● - INDICATES SECTION 96 MODIFICATIONS

ATTIC FLOOR PLAN

GROUND FLOOR PLAN
 Scale 1:100

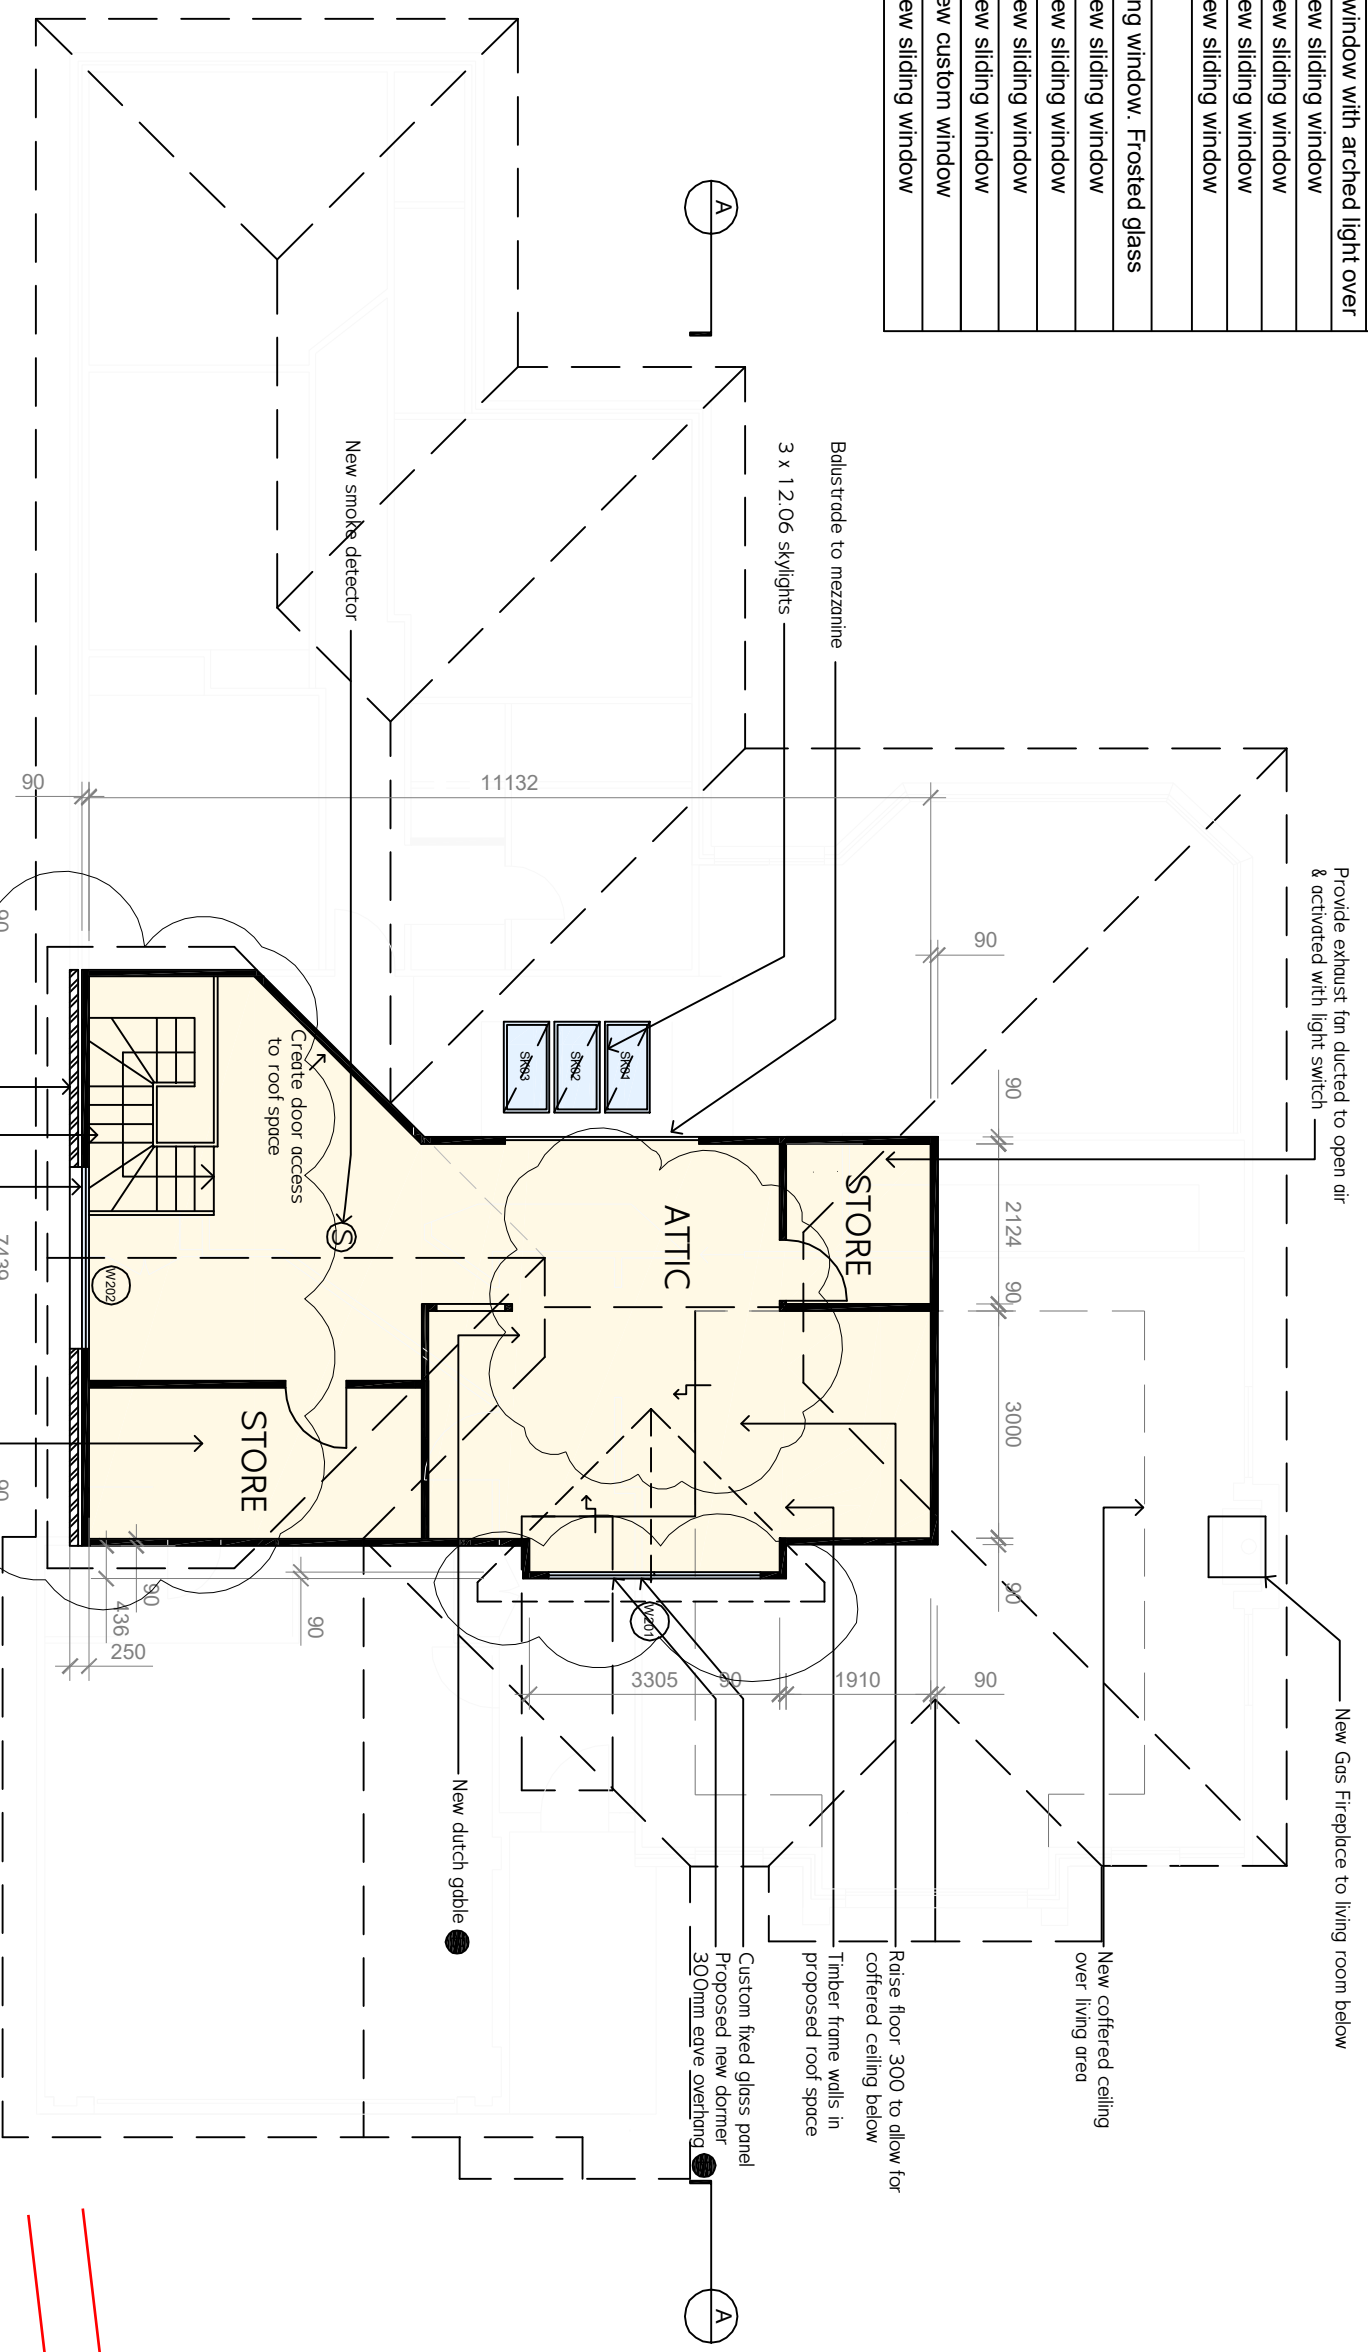
- New bi-folding glazed door set
- Remove existing wall to create new Meads area.
- New beam above to engineer's design
- Close existing window. Make good to match existing dwelling
- New beam to engineer's design
- New closed face timber stairs as selected to BCA requirements

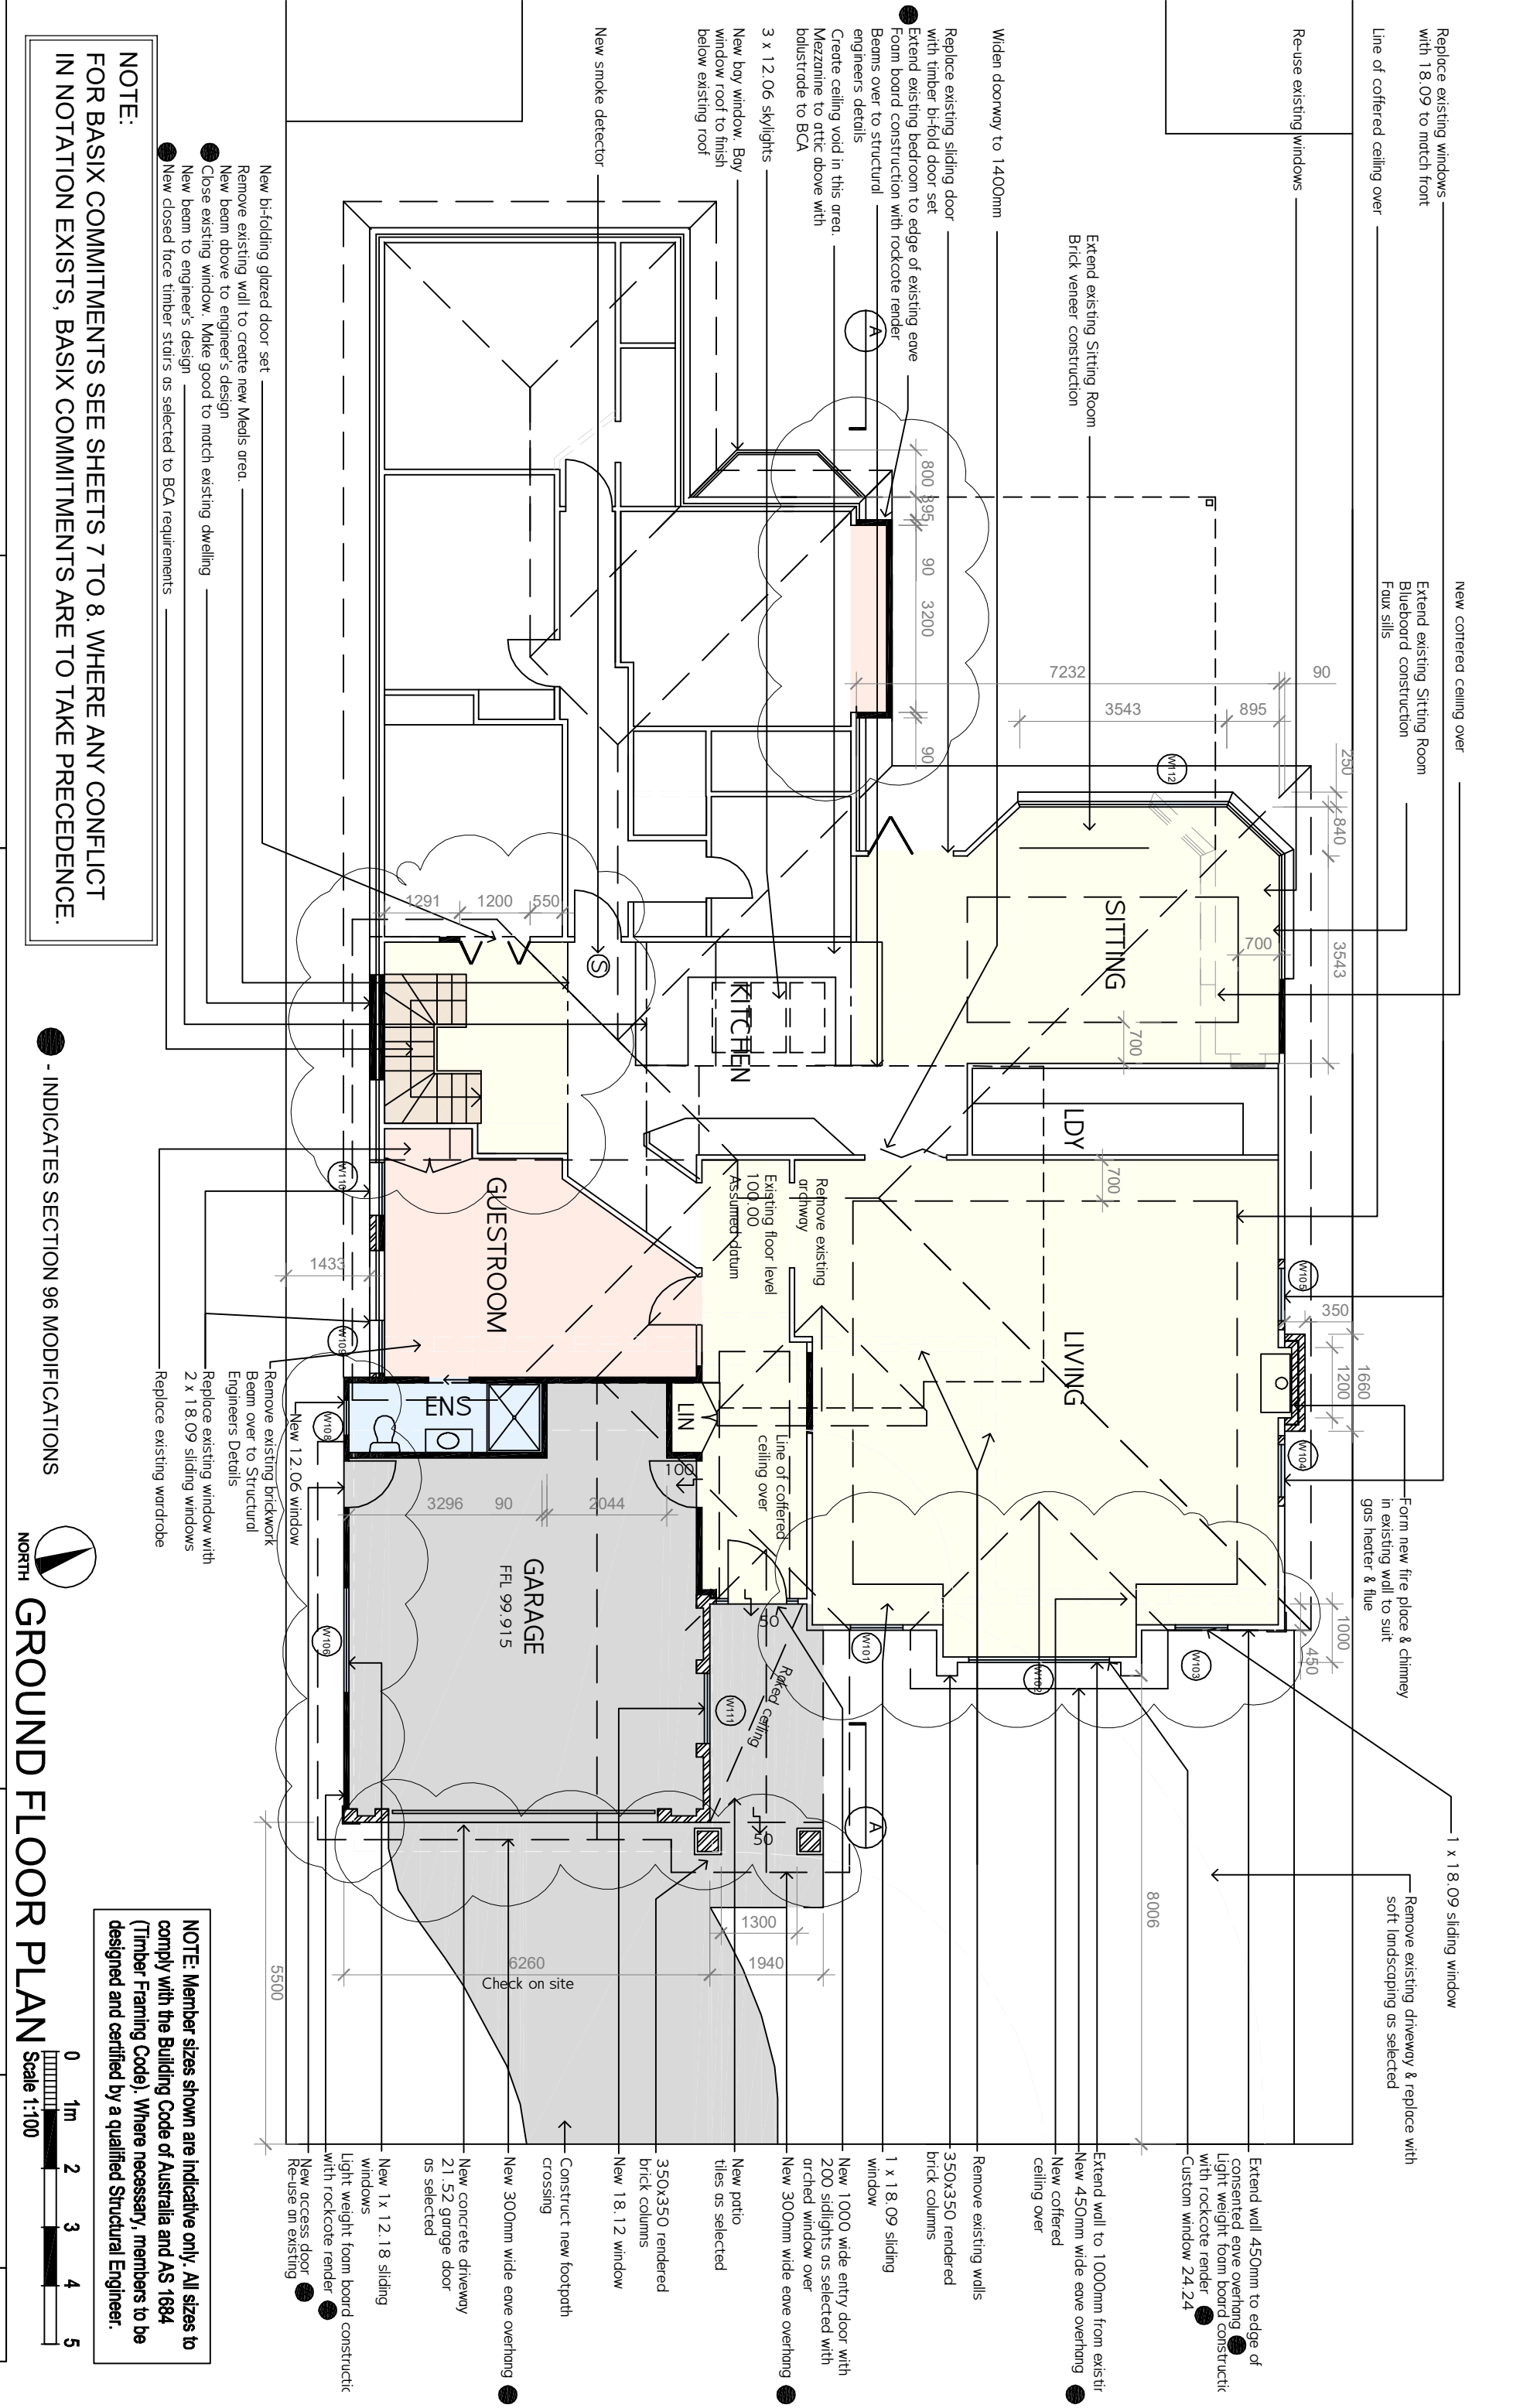
- Increase size of Attic addition
- New closed face timber stairs as selected to BCA requirements
- New 12.24 aluminium frame window
